Freescale Semiconductor Addendum

Document Number: MPC8245UMAD

Rev. 3.2, 02/2009

Errata to MPC8245 Integrated Processor Reference Manual, Rev. 3

Figure 6-41. 8-Bit ROM/Flash Interface—Single-Byte Read Timing

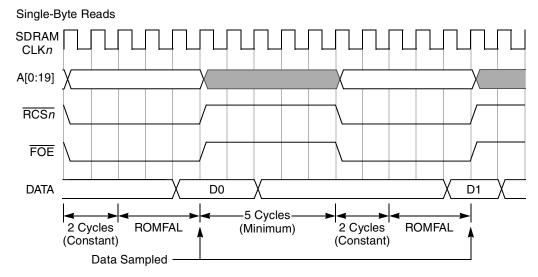
6.2.3, 6-14	In Table 6-9, "SDRAM System Configurations," change entry for "in-line RMW parity enabled" to "INLINE_WR_EN = 0 due to Chip Errata #17."
6.3.4.2, 6-57	Replace Figure 6-41, "8-Bit ROM/Flash Interface—Single-Byte Read Timing," with the following figure:

Figure 6-49. Port X Handshake Mode Read Timing

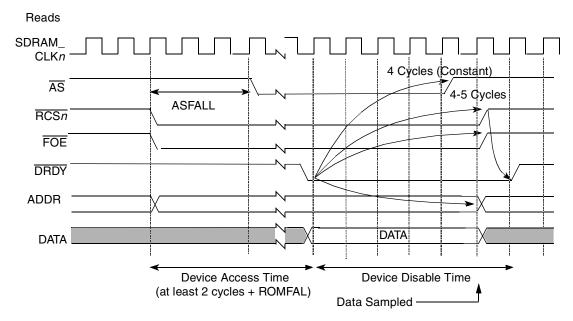
Replace Figure 6-49, "Port X Handshake Mode Read Timing," with the following figure:

Figure 6-50. Port X Handshake Mode Write Timing

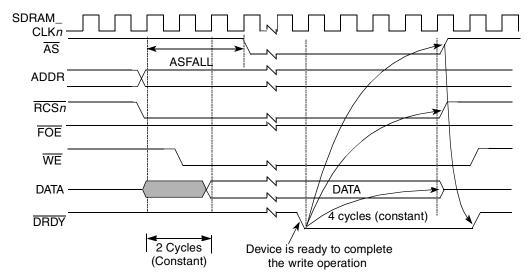
Replace Figure 6-50, "Port X Handshake Mode Write Timing," with the following figure:
